## **Value Engineering** Final Report

# **Hogback Diversion Dam – Fish Screen Project**

**Friday, July 20 2007**

Figure 7. Site Layout for Proposal No. 2

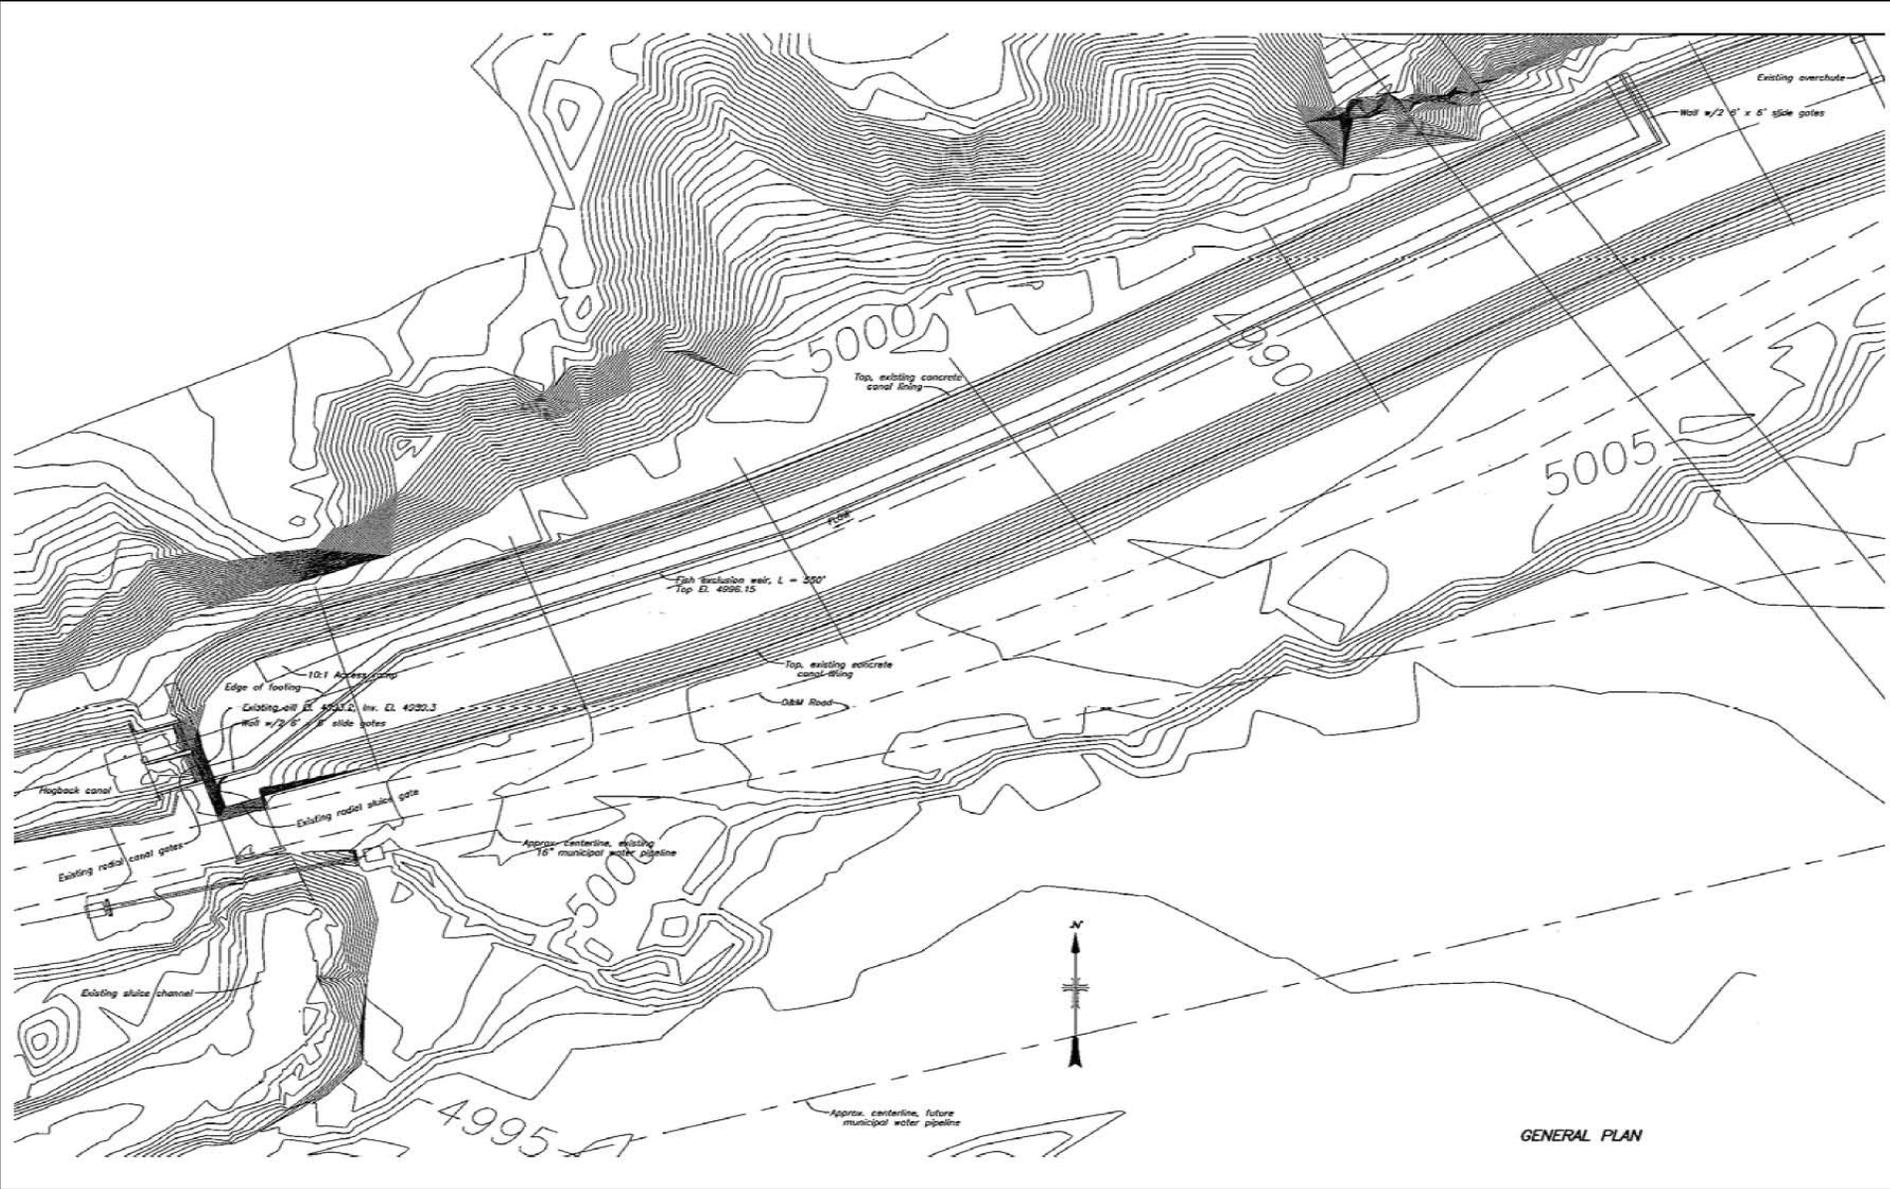
Proposal Description: This proposal consists of a weir wall constructed in the canal in lieu of the proposed fish screen. The weir would skim the top 3-inches of flow and would be approximately 550 feet long to provide a canal flow of 230 cfs. The sluice gates, upstream and downstream, will be provided to allow sluicing of sediment from behind the wall. The existing sluice gate would be automated from the existing gaging station. This is required because it is critical to maintain a consistent water level in order to sustain the canal flow. To enhance maintenance capabilities, a 10:1 access ramp will be provided.

Critical Items to Consider: Continual screening of fish to prevent unintentional diversion into the canal may be problematic due to high bed and debris loads frequently present in the San Juan River. Use of a weir concept would allow only the upper portion (< 4%) of the water column to spill over into the afterbay for canal diversion. This will effectively minimize fish entrainment and also minimize potential downtime of screening due to cleaning and other required maintenance activities.

This proposal is a behavioral barrier instead of a positive barrier. Therefore, it will be necessary to further consult experts familiar with these fish species to ensure that there are no situations where there would be a high percentage of fish being carried over the weir. However, the team

feels this option will potentially provide better fish exclusion over a traditional screening facility that may have intermittent operation.

Ways to Implement: Pre-release acclimation – approval/coordination with water users to hold water and operate after irrigation diversions cease, inclusion of ‘sluice’/exit gate in weir to drain afterbay to sluice return channel, maintenance of water level in afterbay, screening/netting of canal gate to avoid entrainment of stocked fish.
